South Whidbey Aquatic Center

Addendum # 3

June 20, 2025

To All Bidders: Attention is called to the following items effective June 20, 2025, which shall be added to, deleted from, or changed from the BID DOCUMENTS dated June 2, 2025, thereby incorporating the addendum as part of the CONTRACT DOCUMENTS.

T1.2

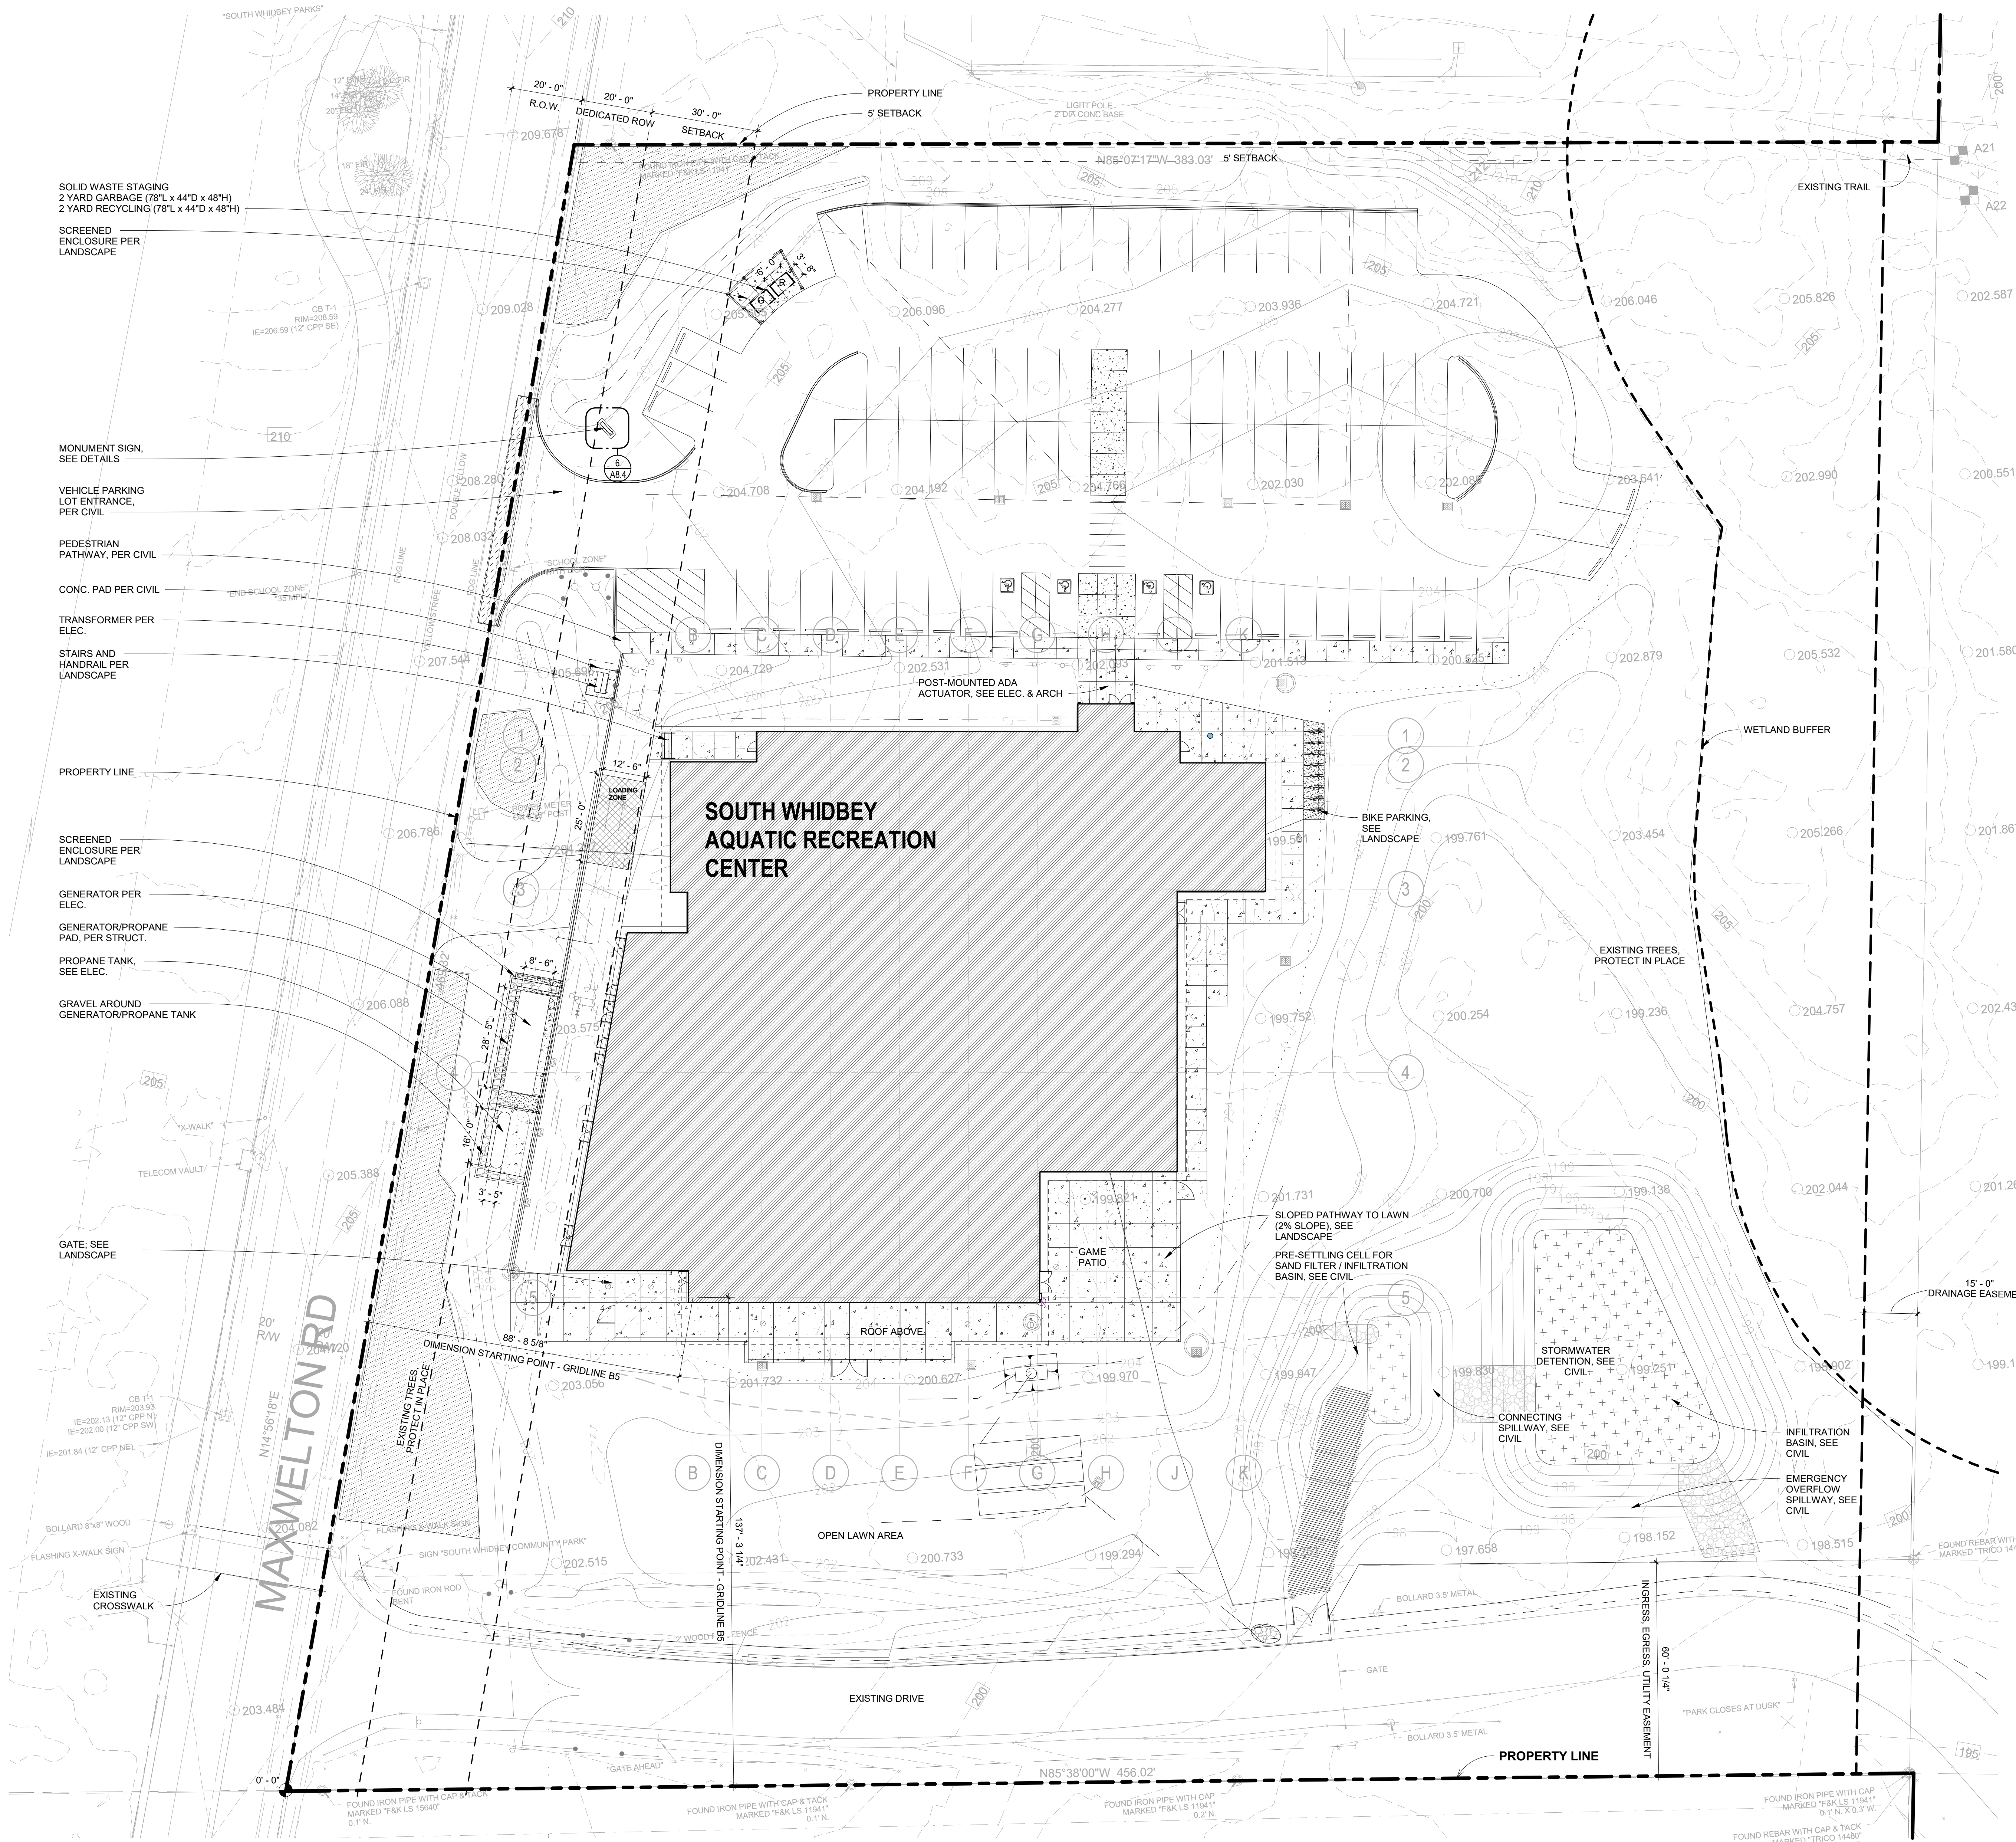
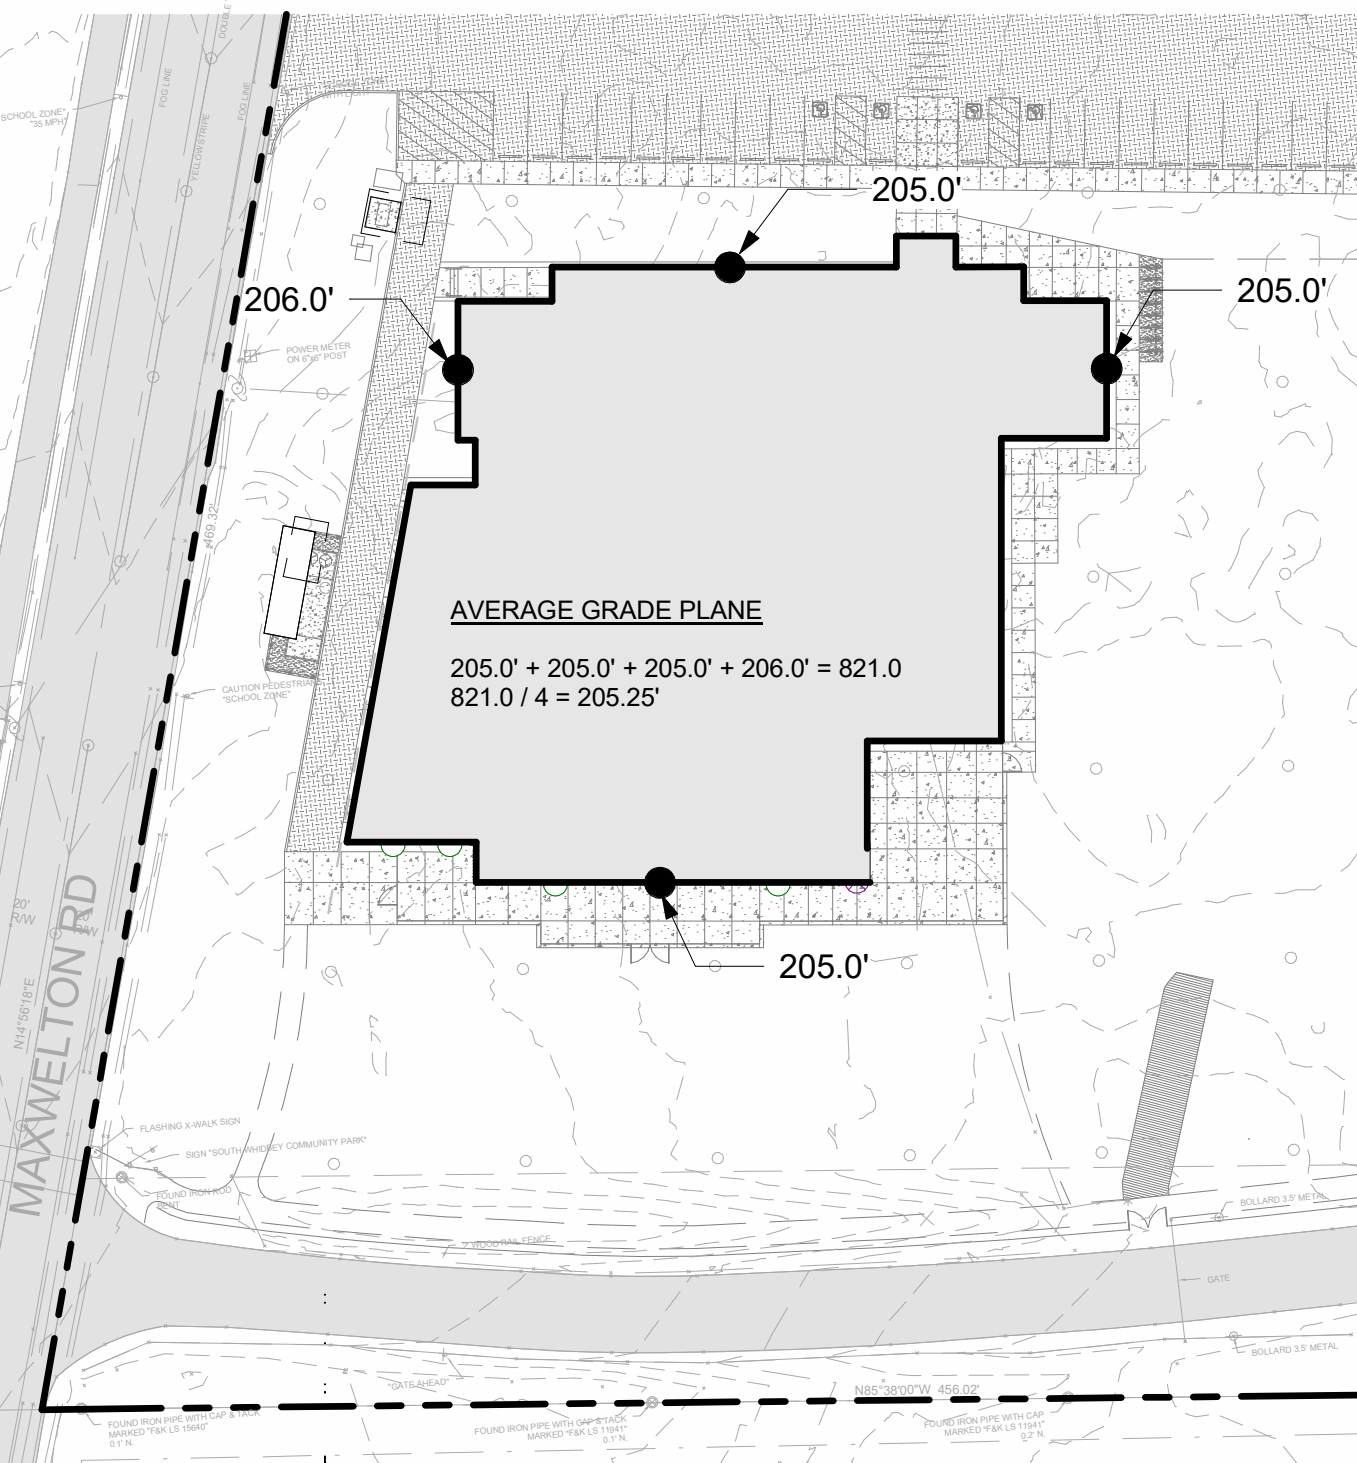
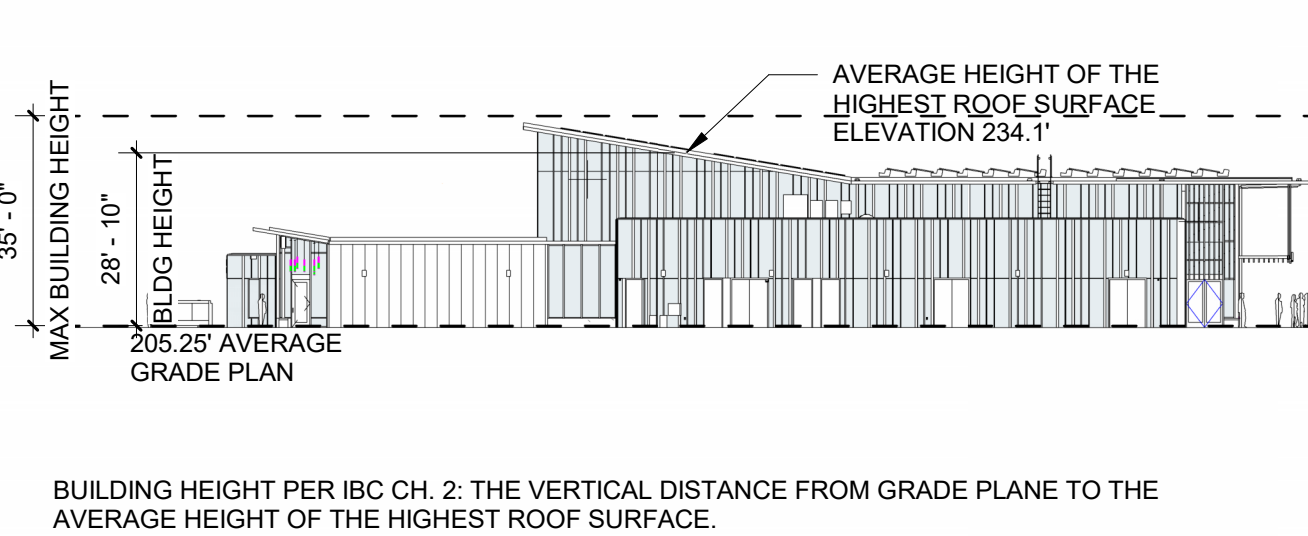
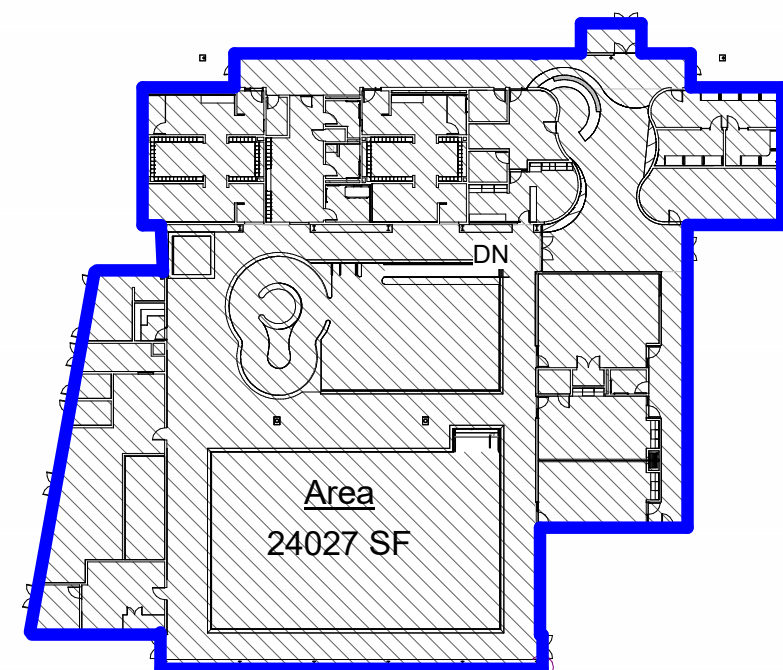
- a. Architectural Drawings
 - i. **REVISE** – T1.1 Energy Code Notes C406 Efficiency Packages changes to read 'C406.2.4.2 Enhanced Lighting Control'.
 - ii. **REPLACE** – Sheets T1.2 in its entirety with the attached revised sheet T1.2.
Changes include:

- 1. **REVISE** Occupant Load table for Business Areas with Sprinkler Protection to read '150sf' for the column 'Area Per Occupant' (Table 1004.5, IBC 2021).

- 2. **REVISE** – Occupant Load table total occupant load to read '613'.
 - 3. **REVISE** – Occupant load summary, total occupants for plumbing calculations to read '= (613- (347 + 43 + 71 + 2)) OCCUPANTS (SEE TABLE 'OCCUPANT LOAD - IBC') + 207 OCCUPANTS (SEE 'PLUMBING CALCS FOR NATATORIUM SPACES PER WAC) = 150 OCCUPANTS (NON-NATATORIUM) + 207 OCCUPANTS (NATATORIUM) = 357 OCCUPANTS'.

SHEET: A1.1

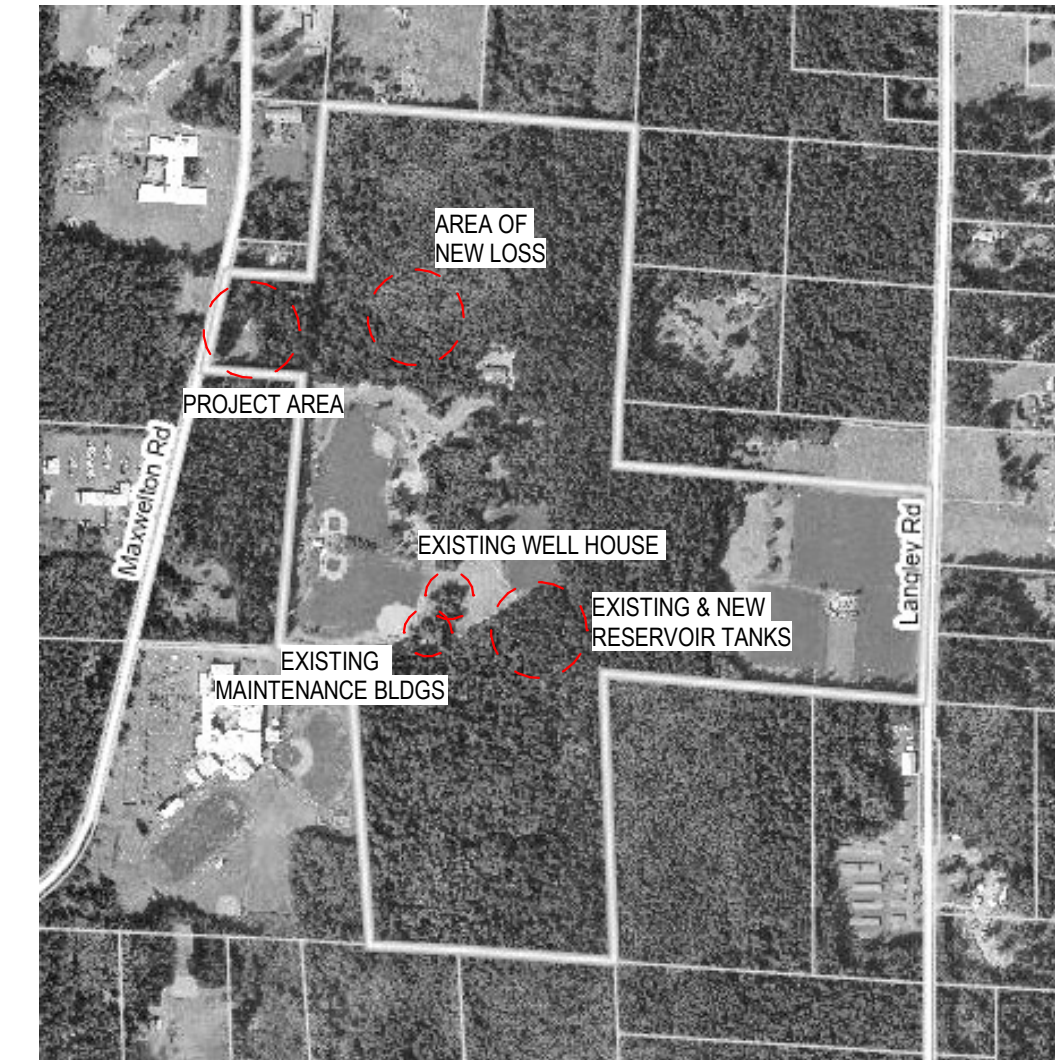
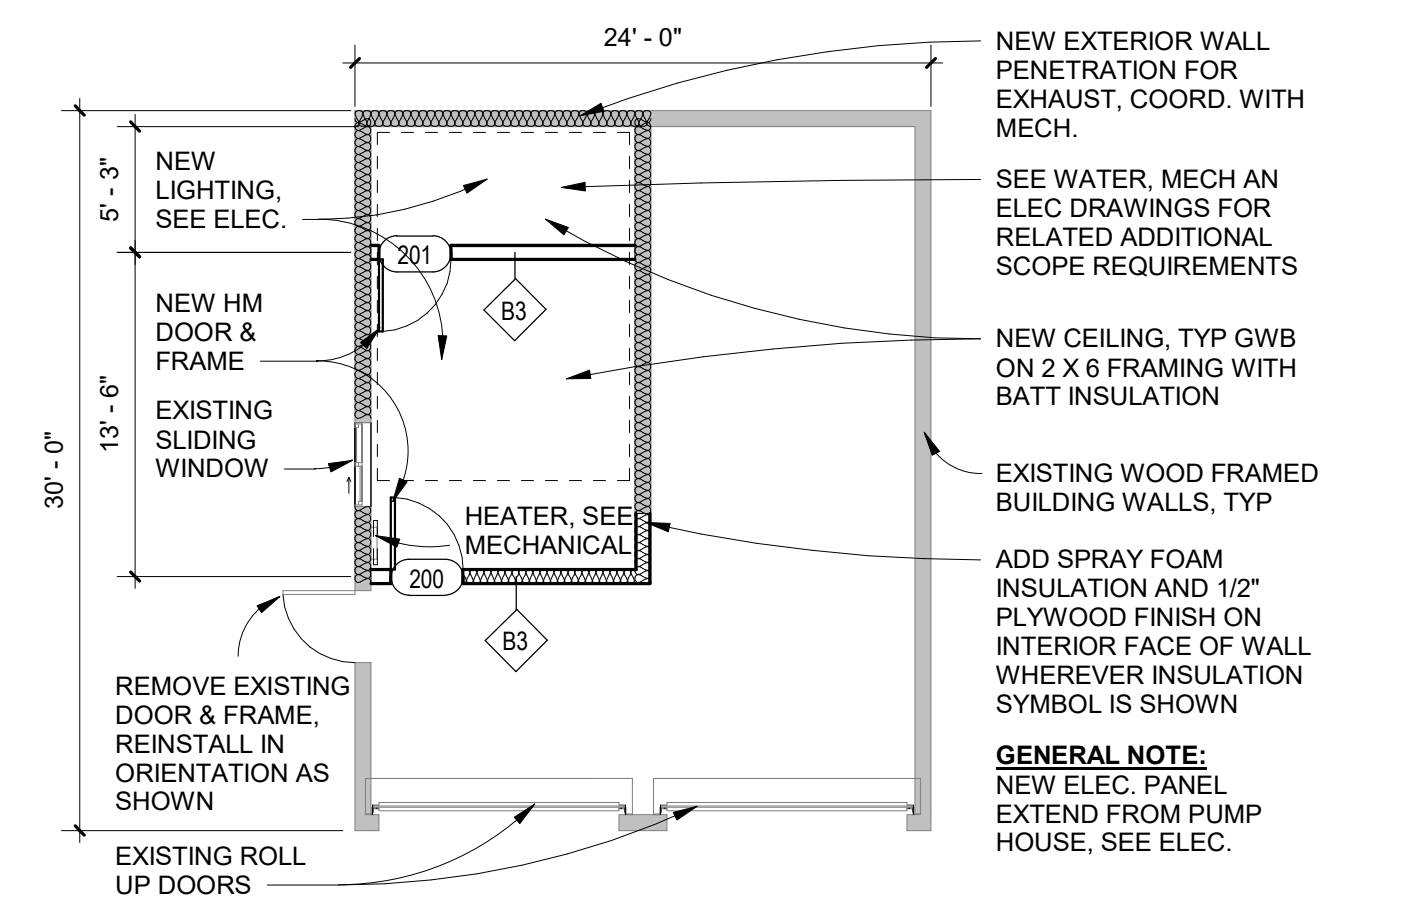
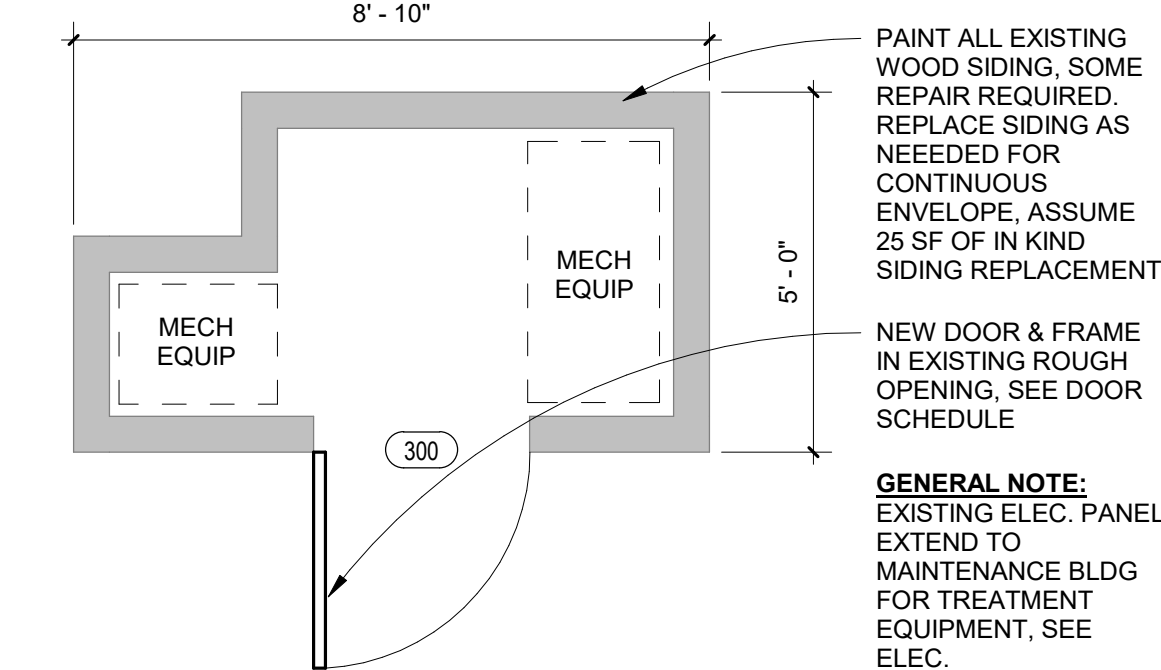
- iii. **REVISE** – A1.1 Site Plan Notes, 8 to read 'THE EXTENTS OF WORK SHOWN ON THIS SHEET INCLUDES LARGE AREAS OF TREE CLEARING, SEE LANDSCAPE DRAWINGS FOR MORE INFORMATION. IN ADDITION TO THE TREE CLEARING REQUIRED BY THE WORK SHOWN ON THIS SHEET, THERE IS ALSO TREE CLEARING REQUIRED BY THE NEW WATER SYSTEM AND LOSS SYSTEM. SEE THE RESPECTIVE SHEETS FOR ESTIMATING THE TREE CLEARING AREAS ASSOCIATED WITH THOSE SCOPES. AT THE LOSS AND WATER SYSTEMS SPECIFICALLY, ASSUME AN ADDITIONAL 30' BUFFER TREE CLEARING AROUND THE DRAINFILED, WATER TANK, AND ASSOCIATED EQUIPMENT.'
